UNITED STATES
NUCLEAR REGULATORY COMMISSION
REGION III
799 ROOSEVELT ROAD
GLEN ELLYN, ILLINOIS 60137

Docket No. 50-546
Docket No. 50-547

IE Bulletin No. 80-20

FAILURES OF WESTINGHOUSE TYPE W-2 SPRING RETURN TO NEUTRAL CONTROL SWITCHES

FIGURE 1:

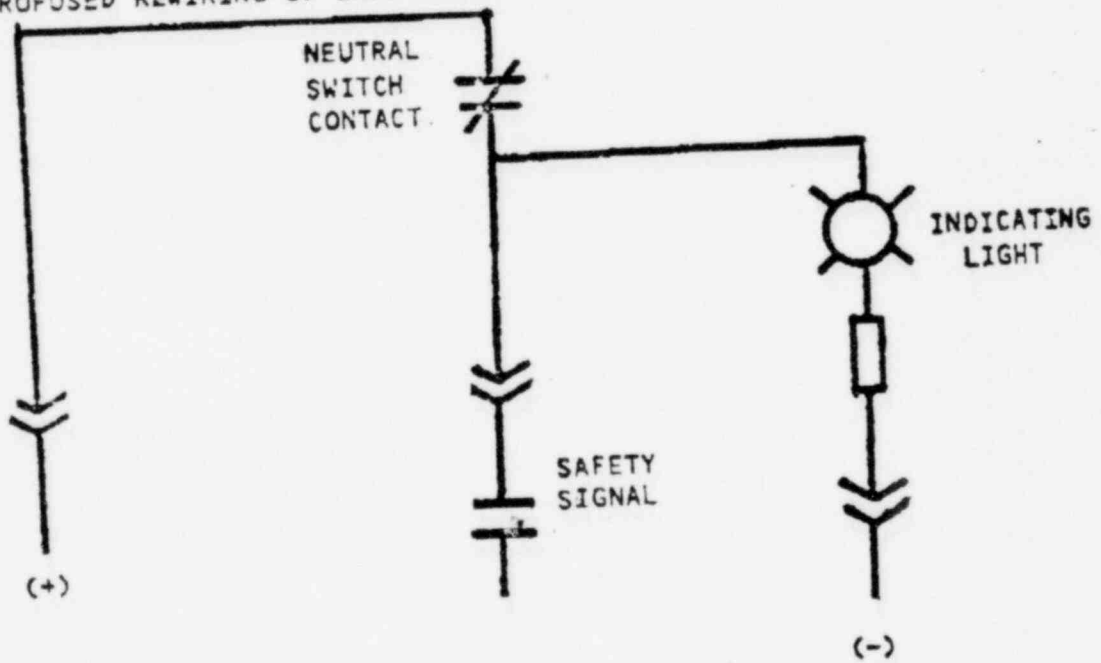
A review of this matter by Westinghouse led to the issuance of NSD Technical Bulletin No. NSD-TB-80-9 to the utility owners of all Westinghouse operating plants. The recommendations contained in the Westinghouse technical bulletin include: (i) testing the neutral position contacts of the subject W-2 switches for continuity, and (ii) rewiring of the indicating light circuit to permit the early detection of a neutral contact failure as shown in Figure 1.

Depending on how the indicating light circuit is wired, loss of continuity thru the neutral position contact of a W-2 switch could remain undetected until the equipment associated with the switch were called upon to operate. Since such a failure would be equivalent to by-passing the system associated with the switch, consideration should be given to rewiring the switches used in safety-related applications as shown in Figure 1. Such rewiring would provide an acceptable means for detecting contact failure, provided the indicating light is in the control room and readily visible by the operator. If the indicating light is not so located, consideration should be given to annunciating the neutral position contact failures at the control room to alert the operator of the inoperable status of a safety-related system. In addition, consideration should be given to adding redundant contacts to the W-2 switches or to replacing the W-2 switches with others having a more positive contact wiping action.

3. Licensees of operating plants and holders of construction permits shall describe the longer term corrective measures planned and the date by which such measures will be implemented by actual installation or by design change, as appropriate. As a minimum, the longer term corrective measures should include rewiring the indicating light as shown in Figure 1 provided the light is readily visible to the control room operator. If not, failures of the neutral position contacts should be annunciated in the control room.

REWIRING OF INDICATING LIGHT CIRCUIT OF W-2 SWITCHES
AS RECOMMENDED BY WESTINGHOUSE TECHNICAL BULLETIN NSD-TB-80-9
